**COMMISSION OF ARCHITECTURAL REVIEW
STAFF REPORT
April 25, 2017, Meeting**

4. **COA-015011-2017** (T. Sullivan)

**815 North 22nd Street
Union Hill Old and Historic District**

**Rehabilitate the existing structure
and construct a 2 story rear addition.**

Existing Condition of the Façade of 815 North 22nd Street

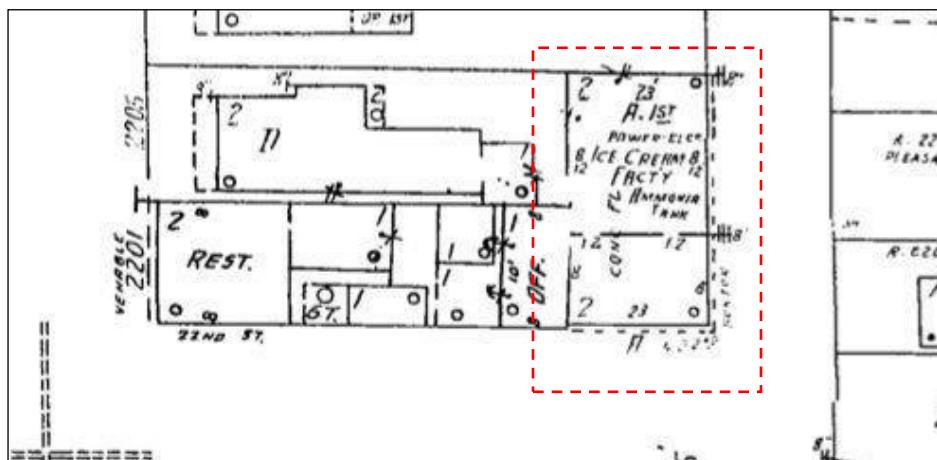
The applicant is proposing to rehabilitate the existing historic structure by installing 2/2 aluminum clad wood windows with simulated divided lites in the existing openings. The applicant is proposing to include segmental arches in the window openings. On the façade, the applicant is proposing to install double doors in both the existing first and second story openings.

Rehabilitation of the Historic Structure: The proposed rehabilitation is in general in keeping with the Standards for Rehabilitation found on page 55 of the *Richmond Old and Historic Districts Handbook and Design Review Guidelines*. The Guidelines note that original features that define the building style should be maintained, and the applicant is achieving this by maintaining the asymmetrical composition of the façade. The Guidelines also note that the design of missing elements should be based on pictorial, historical, or physical evidence. The existing openings have been altered over the years, and the applicant is proposing to reintroduce segmental arches in the window openings to be consistent with the historic window openings. The photographic evidence shows a double door on the second floor of the façade and a storefront opening on the ground floor. Staff supports the restoration of double doors on the second floor and recommends the applicant increase the size of the ground floor opening on the façade to be more consistent with the historic opening as shown in the photographic documentation in a manner to be reviewed and administratively approved by staff. Staff is unable locate photographic evidence of the historic window sashes, and therefore staff supports the installation of the 2/2 aluminum clad wood windows with simulated divided lite as the proposed windows are compatible with windows in the district.
